State of Illinois  
Illinois Department of Transportation

Addendum  
MANUAL FOR FABRICATION OF PRECAST PRESTRESSED CONCRETE PRODUCTS

Replace figure on page A-53 with the following:

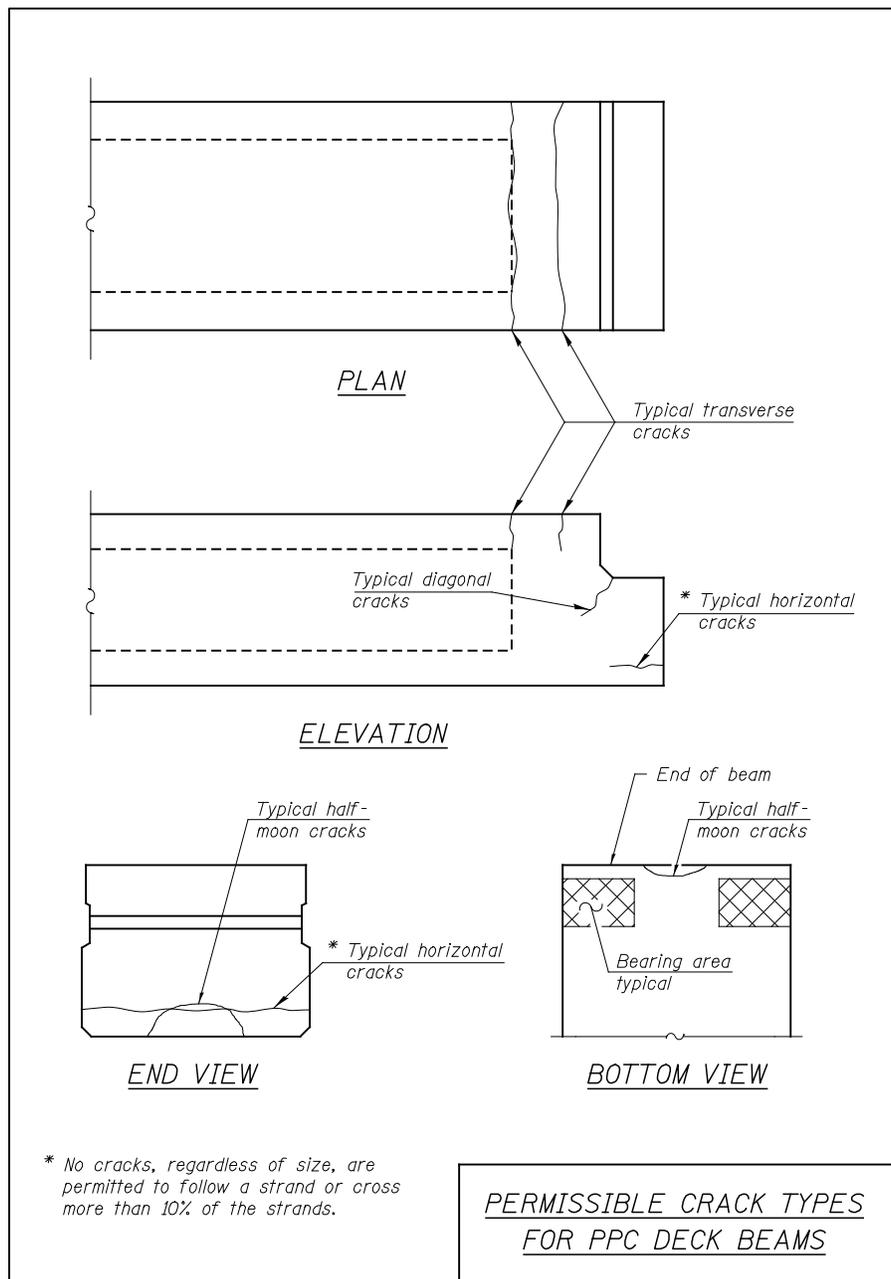
Section 3.5.4, 1. Splitting Cracks at Beam Ends

Under Permissible Crack Guidelines for Deck Beams, add item #4 as follows:

4. "Half-moon" cracks as shown in Appendix A may occur in prestressed beams when most of the permissible strand locations are utilized in the center. The maximum crack width for this type of crack is 0.007 in. (0.18 mm). In some cases, especially if the crack wraps around the underside of the beam, the concrete inside the crack may be unsound, and if that is the case, the rules in Section 3.5.3 shall be followed.
